## NEW HP Sheet Information

### NEW1 ST stage poppet Code No.

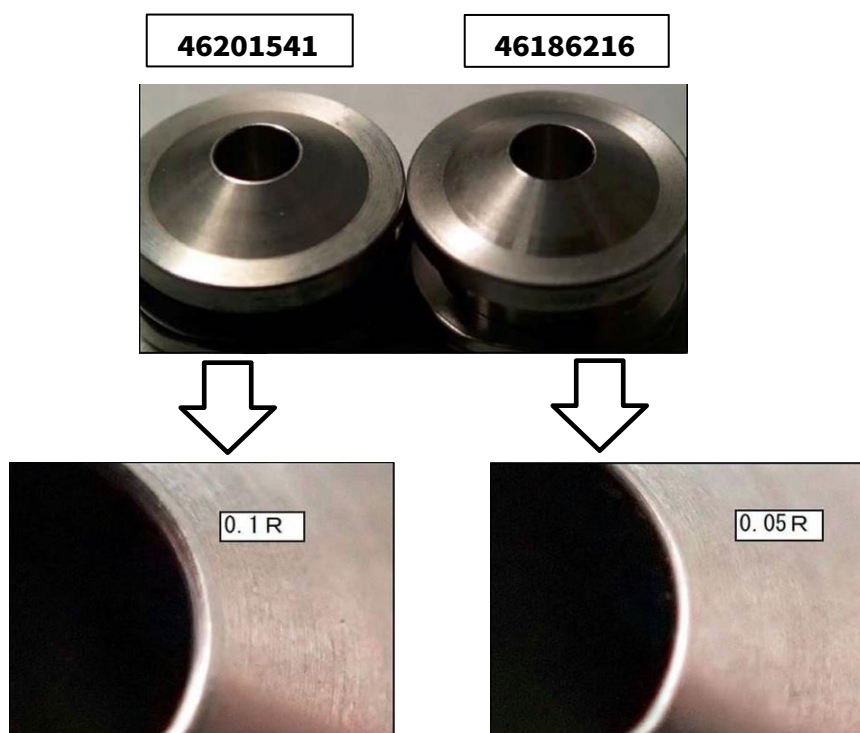
Males Technical Support is pleased to announce a new high pressure seat (#46201541) for the 1ST stage. This seat is designed for optimal performance in combination with the #46201575 TRI Material Poppet 2K18 and is already incorporated into the 1ST stage currently in production. The previous sheet (#46186216) and the new sheet (#46201541) have a different tip diameter. (see photo)

**Conventional**

**46186216 Poppet sheet (MR series)**

**→New NEW**

**46201541HP Sheet (MR)**

\*The conventional product shown above (part no. 46186216) can be used without modification with 46201575 TRI Material Poppet 2K18.

This new sheet will also work with conventional high pressure poppets (46201361 ACT poppet, 46200652 TRI material poppet). (However, ABYSS NAVY II should use 46186216 per US Navy standards.)
